BAYOU DUPRE
CONTROL STRUCTURE

PERIODIC INSPECTION REPORT NO. 2

SUBJECT: Lake Pontchartrain, Louisiana and Vicinity, Chalmette Area Plan;
Bayou Dupre Control Structure, Periodic Inspection Report No. 2,
Mar 1980

1. The inclosed periodic inspection report is approved subject to the following comments:

SETTLEMENT REFERENCE MARKS
DIFFERENTIAL SETTLEMENT CHART

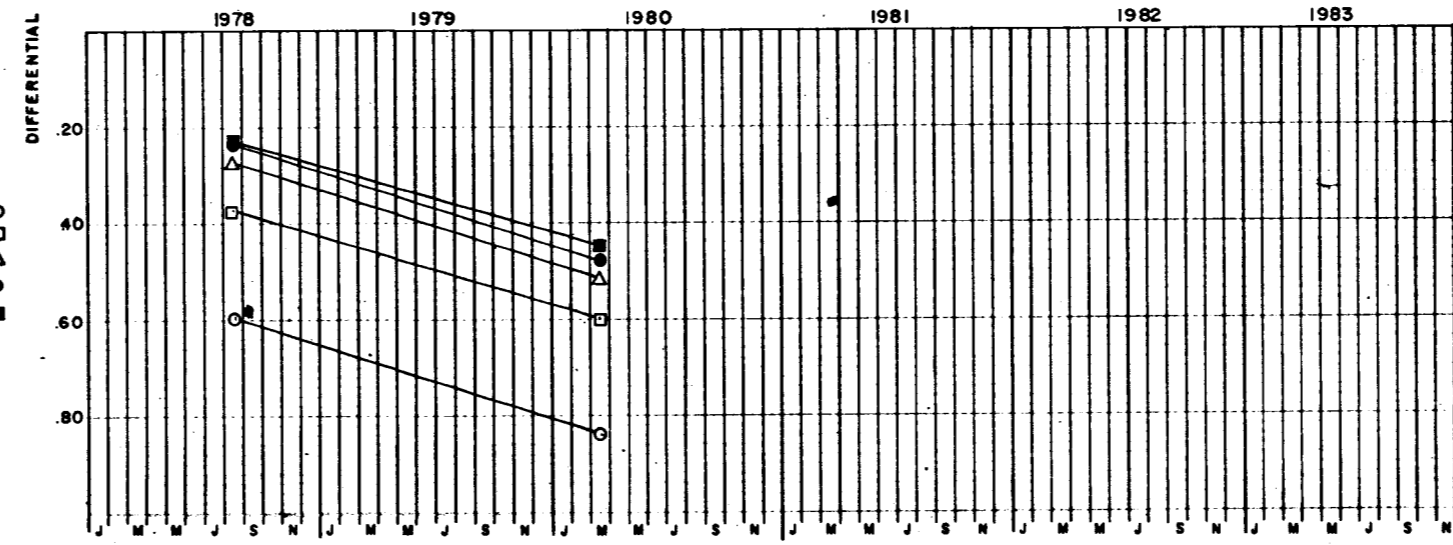
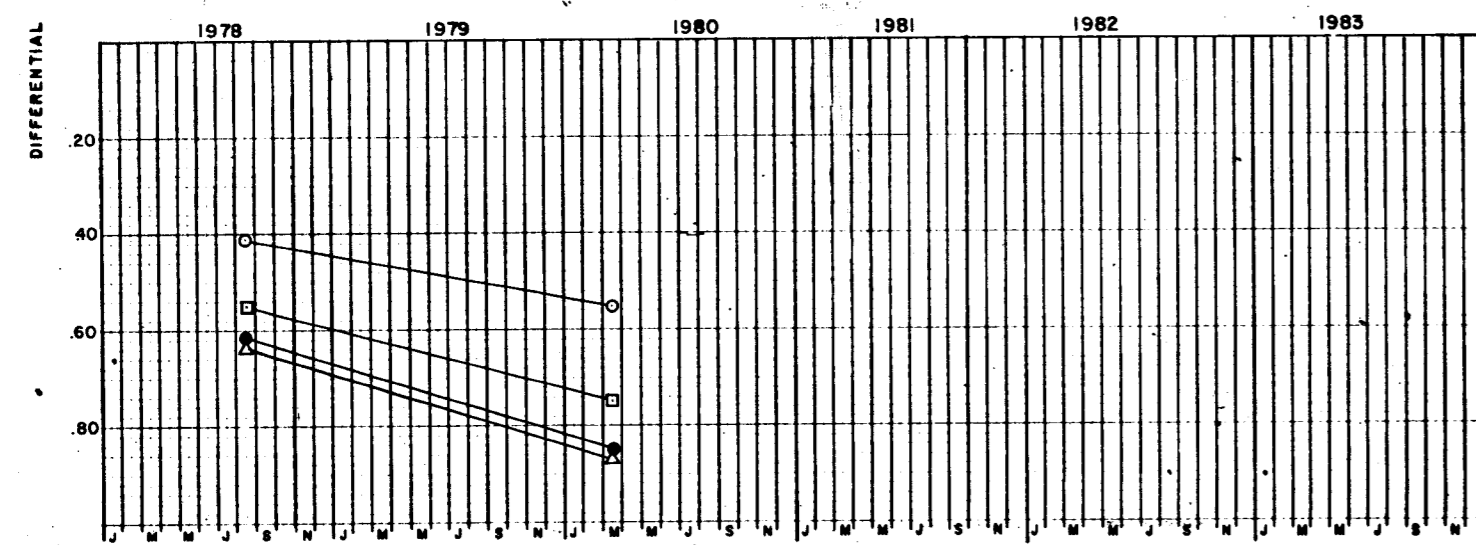
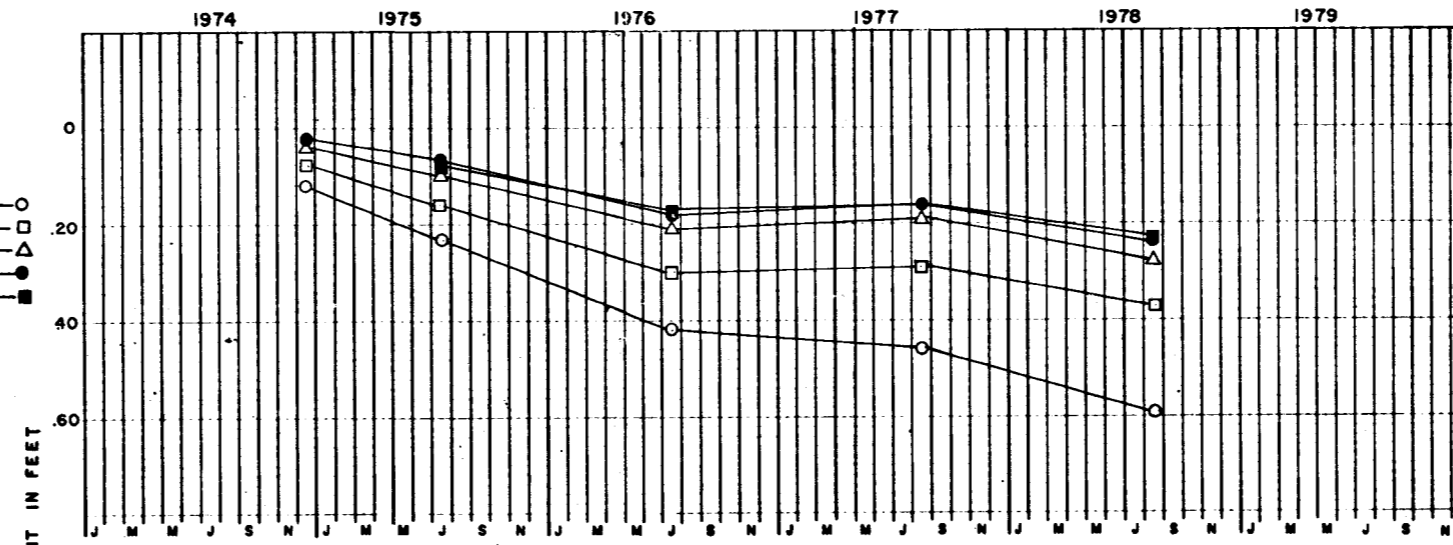
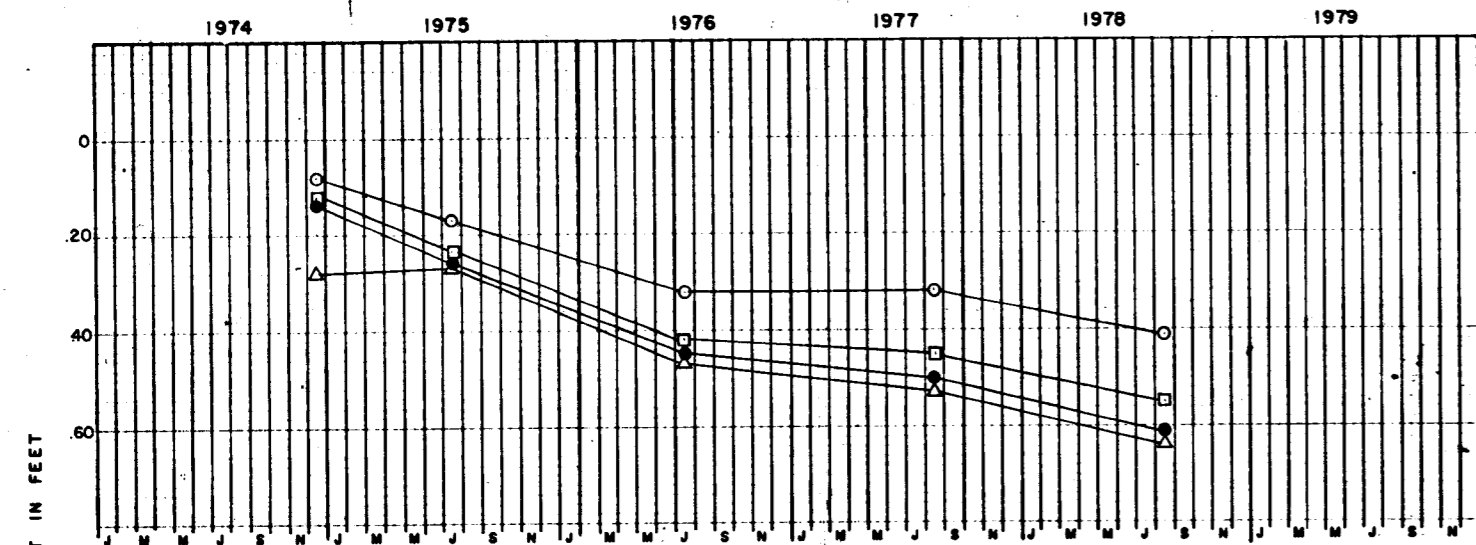
Disposition of comments presented in the previous 2d Ind is satisfactory.
The time-settlements plots referenced in para b of your 2d Ind should be
submitted without delay to this office by 4th Ind to this chain of
correspondence.

The time settlement plots, referenced in paragraph b of the 2d Ind of
this chain of correspondence, are submitted in duplicate for your file
copies of the subject inspection report.

SETTLEMENT REFERENCE MARKS PLAN AND PROFILE

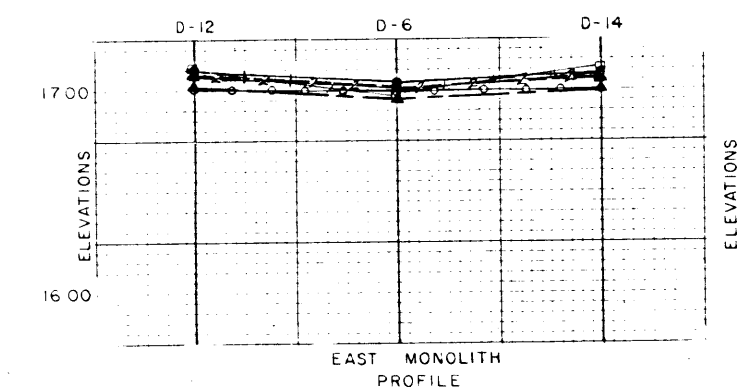
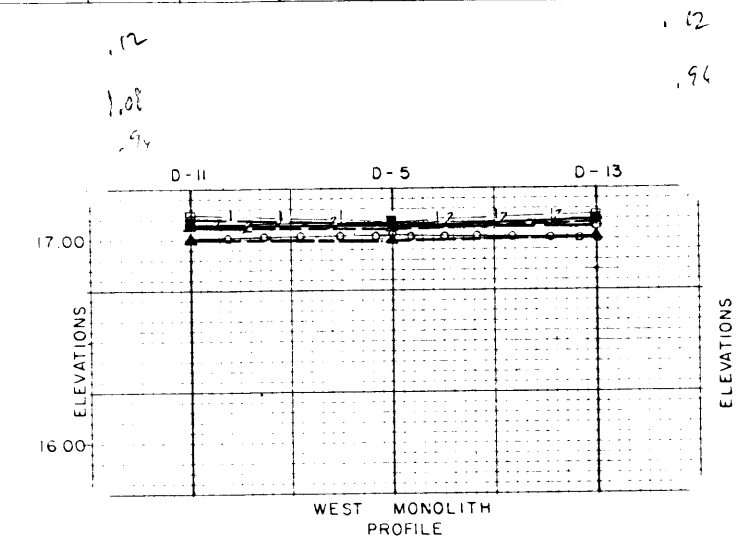
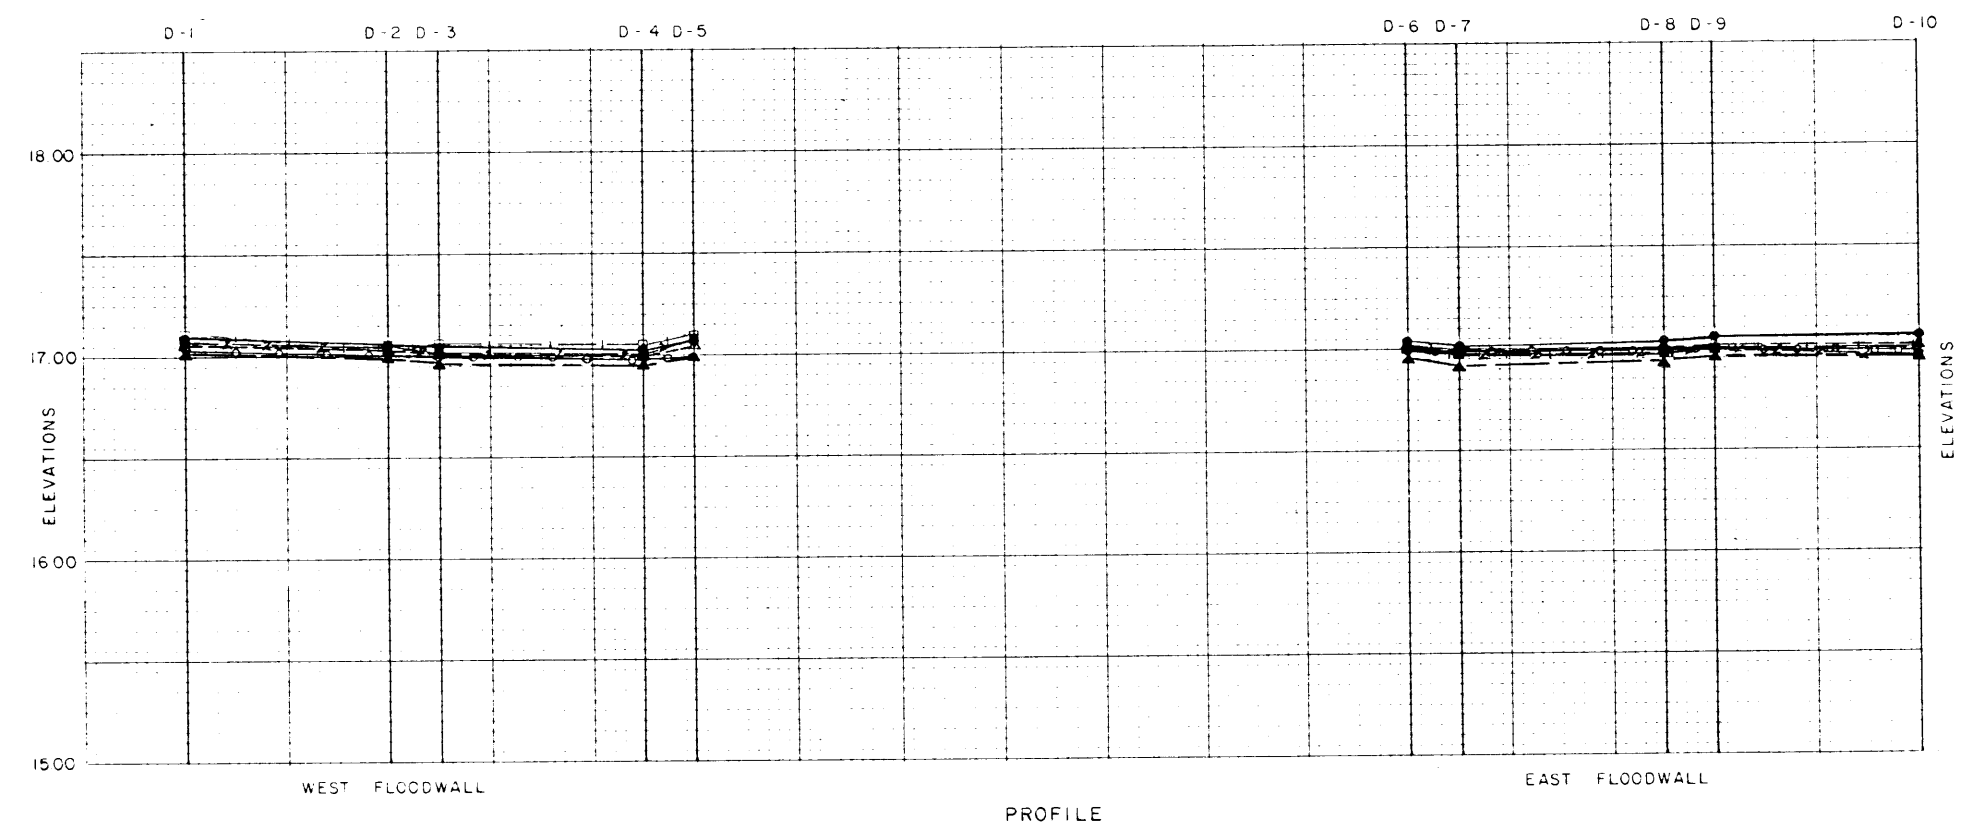
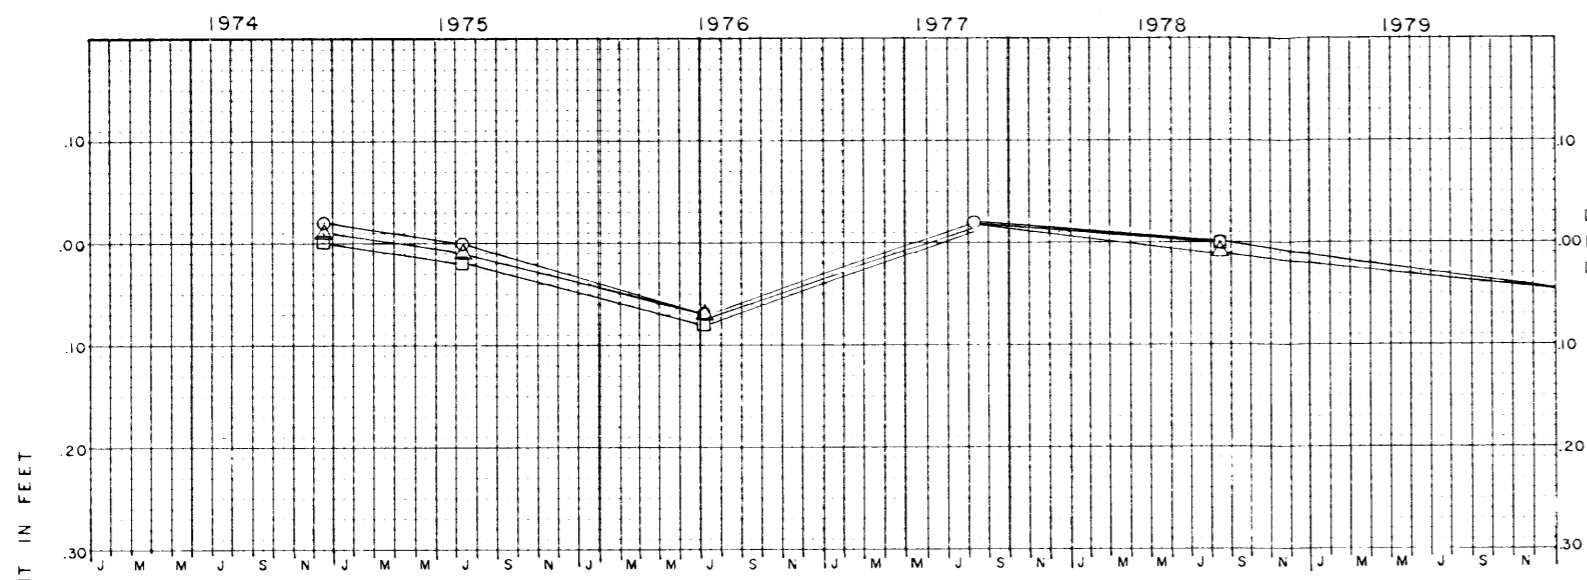
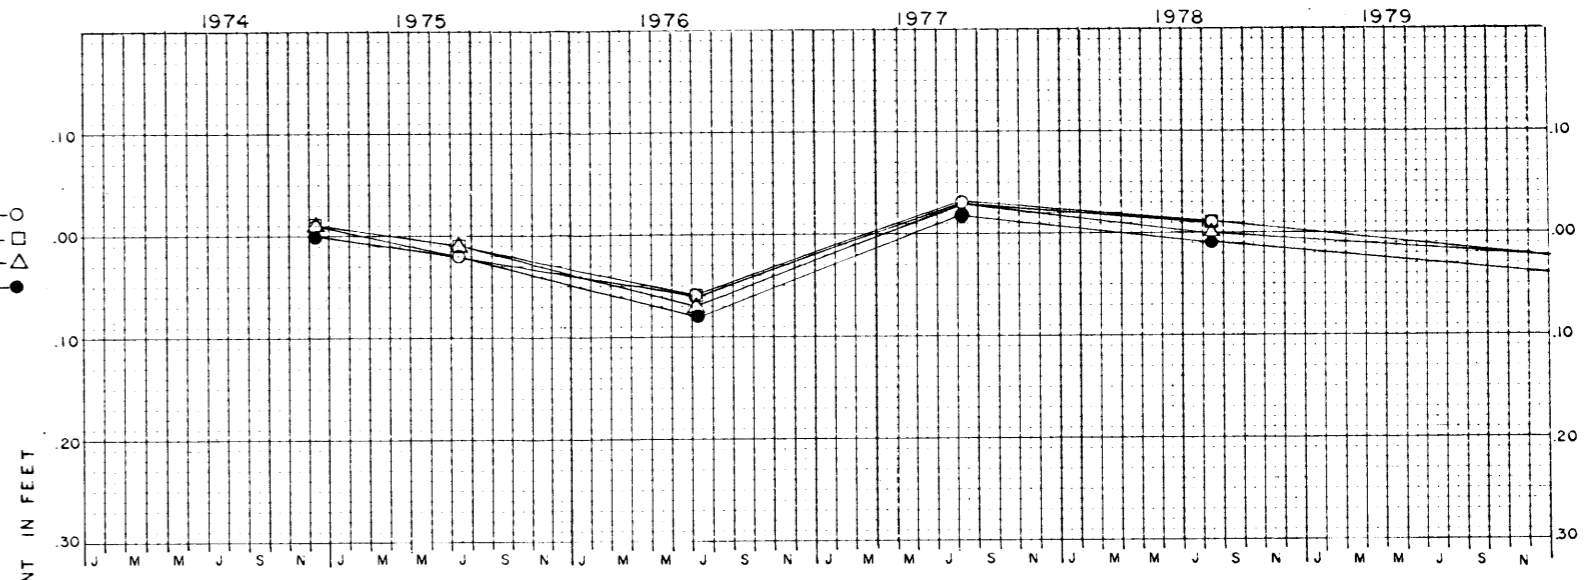
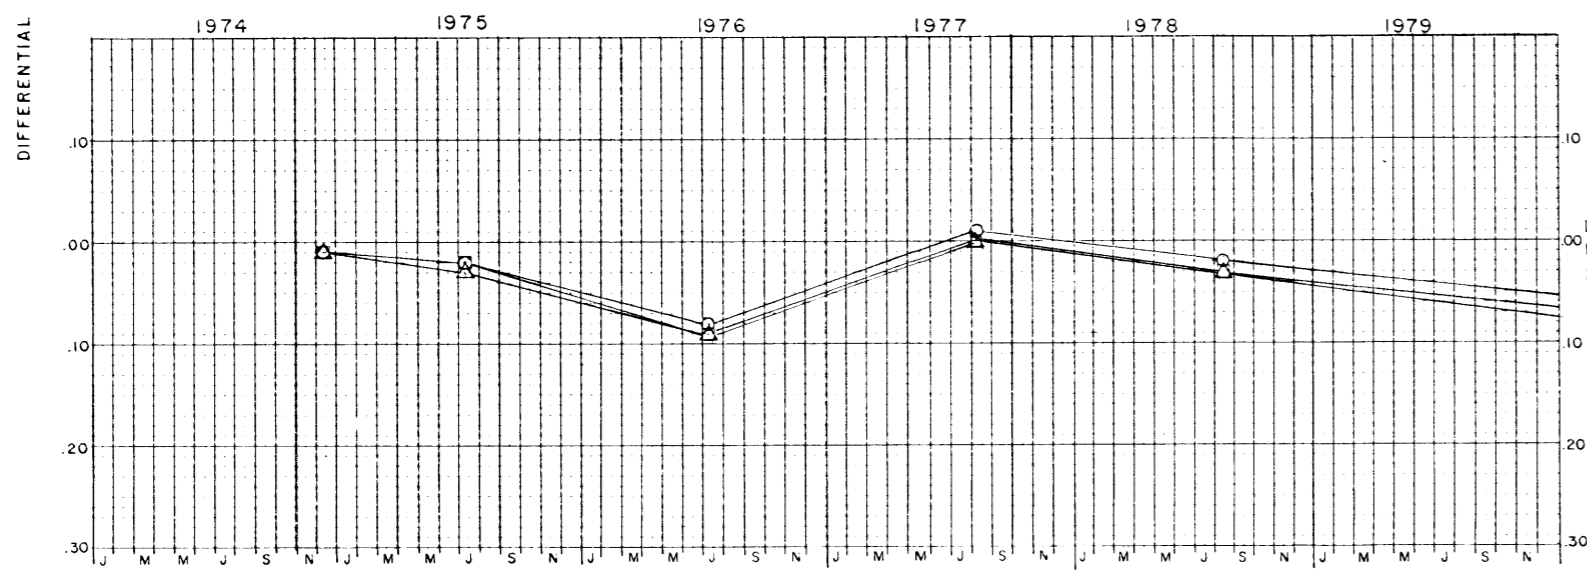
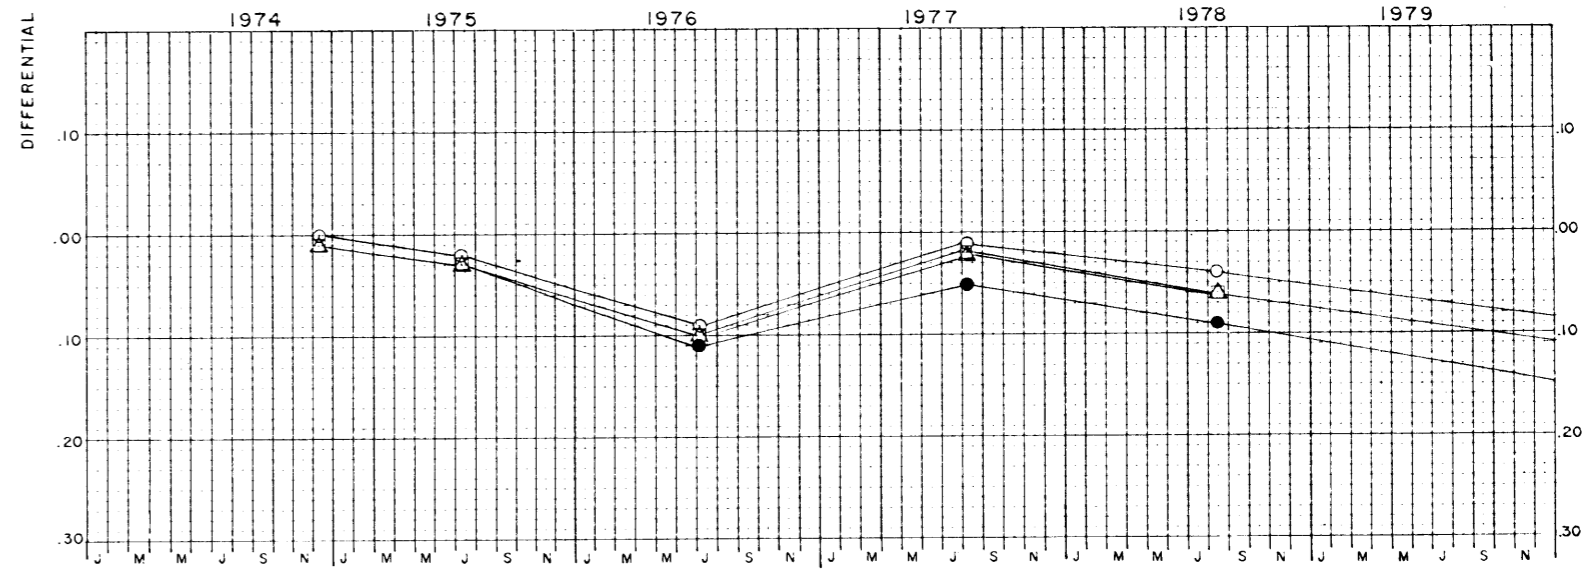
(1) Settlement data on Plate 6 indicate that the east concrete-sheetpile wall has settled from 0.6 to 0.9 ft since it was constructed. The rate and magnitude of settlement and the significance of this settlement should be discussed in para 4-03a. In this regard, time-settlement plots of the reference marks on this wall should also be included in this report.

g. Refer to comments in red on pages V-1, V-2, V-3, and Plates 6
and 7.

(1) A discussion concerning the settlement of the east concrete - sheetpile wall has been included in paragraph 4-03a. See inclosure 2, revised page IV-1. Time - Settlement Plots of the referenced marks are presently being prepared. Copies of these plots will be issued upon completion.

g. Referenced comments have been resolved on pages V-1, V-2, V-3. Plates 6 and 7 will be issued upon completion of revisions. See inclosure 4.
